To: T10 Technical Committee
From: Rob Elliott (elliott@hp.com) and Wayne Bellamy, HP (wayne.bellamy@hp.com)
Date: 30 November 2004
Subject: 04-218r6 SAT INQUIRY contents

Figure 1 — Identification descriptors included by a SATL in an ATA host

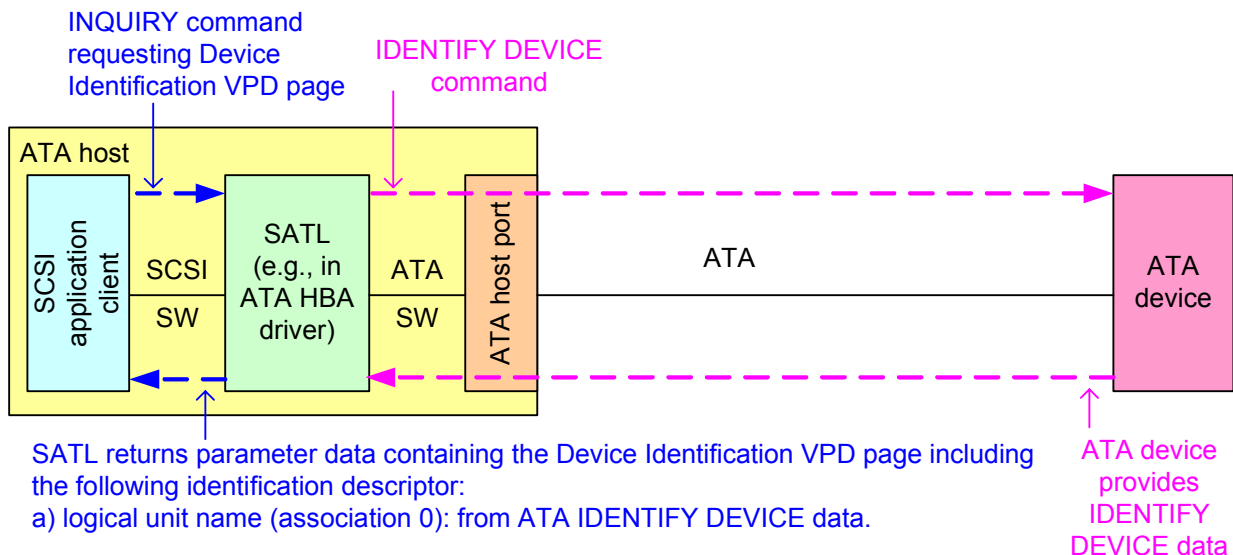
Figure 1 shows the identification descriptor returned by a SATL in an ATA host (i.e., where the ATA device is being accessed with an ATA host port):

- a) a logical unit name (see table 7 or table 9 in 8.1.3.2.2).

Figure 2 — Identification descriptors included by a SATL in a SAS initiator device

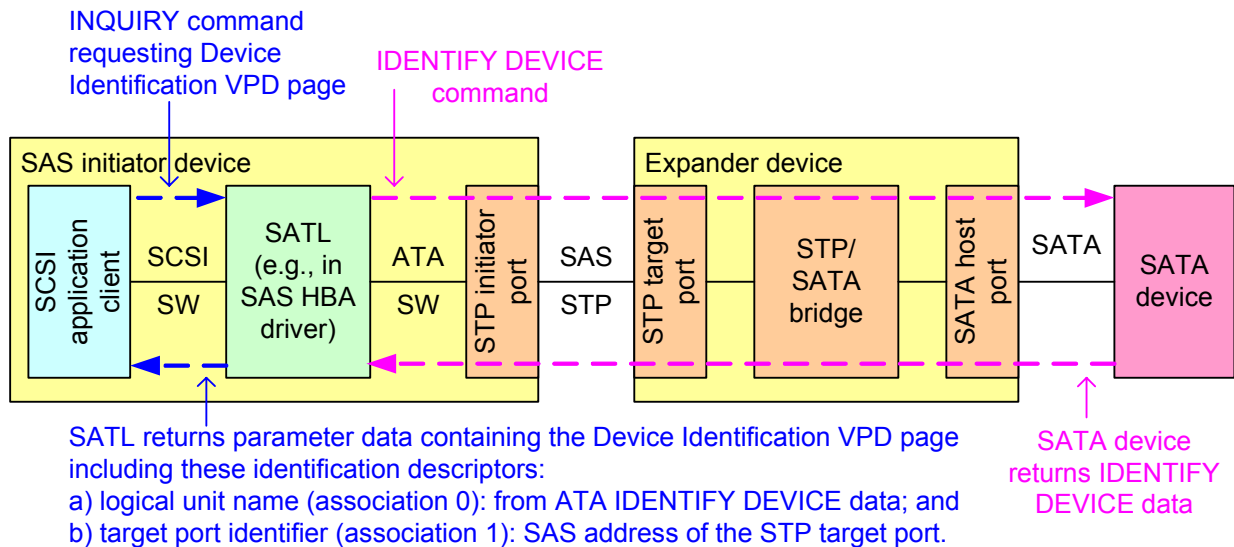
Figure 2 shows the identification descriptors returned by a SATL in a SAS initiator device (i.e., where the SATA device is being accessed with a SAS STP initiator port):

- a) a logical unit name (see table 7 or table 9 in 8.1.3.2.2); and
- b) a SAS STP target port identifier (see table 11).

The SATL shall include a target port identifier as defined in table 11.

The SAS ADDRESS field shall be set to the SAS address of the STP target port providing the STP/SATA bridge functionality (i.e., the SAS address of the ATA device in the SAS domain)(e.g., see figure 2).

Figure 3 — Identification descriptors included by a SATL in a SCSI to ATA protocol bridge

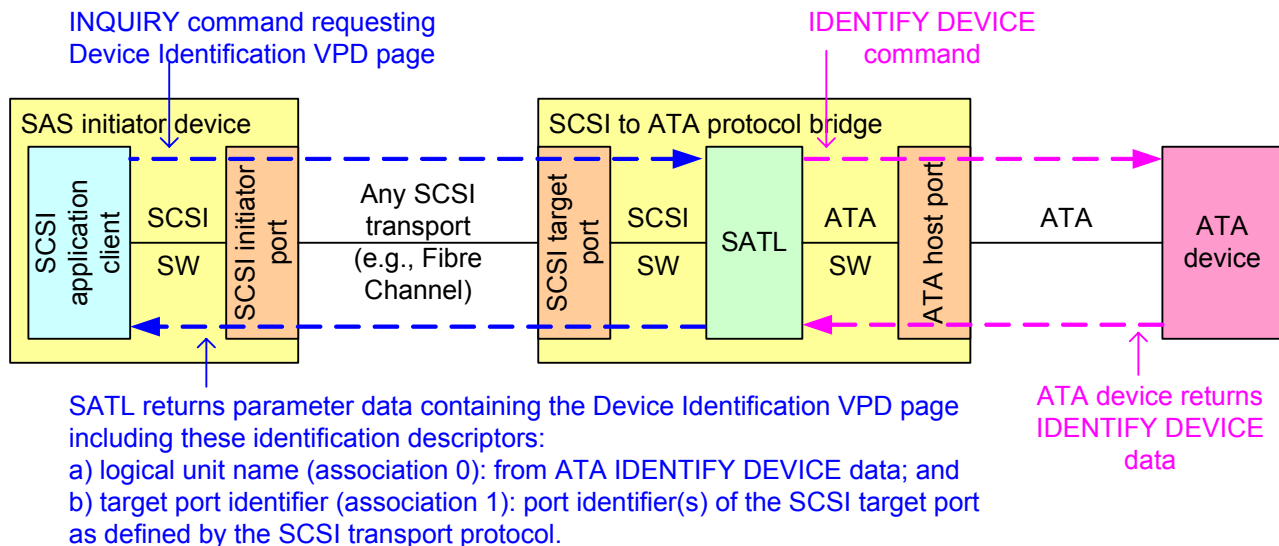
Figure 3 shows the identification descriptors returned by a SATL in a SCSI to ATA protocol bridge, where the ATA device is being accessed by an ATA host port, and the SATL is being accessed with a SCSI target port using a SCSI transport protocol (e.g., FCP-3 or iSCSI):

- a logical unit name (see table 7 or table 9 in 8.1.3.2.2;
- any target port identifiers specified by the SCSI transport protocol standard (e.g., for FCP-3, the SATL includes an identifier with identifier type 3h (i.e., NAA) containing the Port_Name, and may include an identifier with identifier type 4h (i.e., relative target port identifier)); and
- any other identification descriptors supported by the protocol bridge (e.g., a target device name).
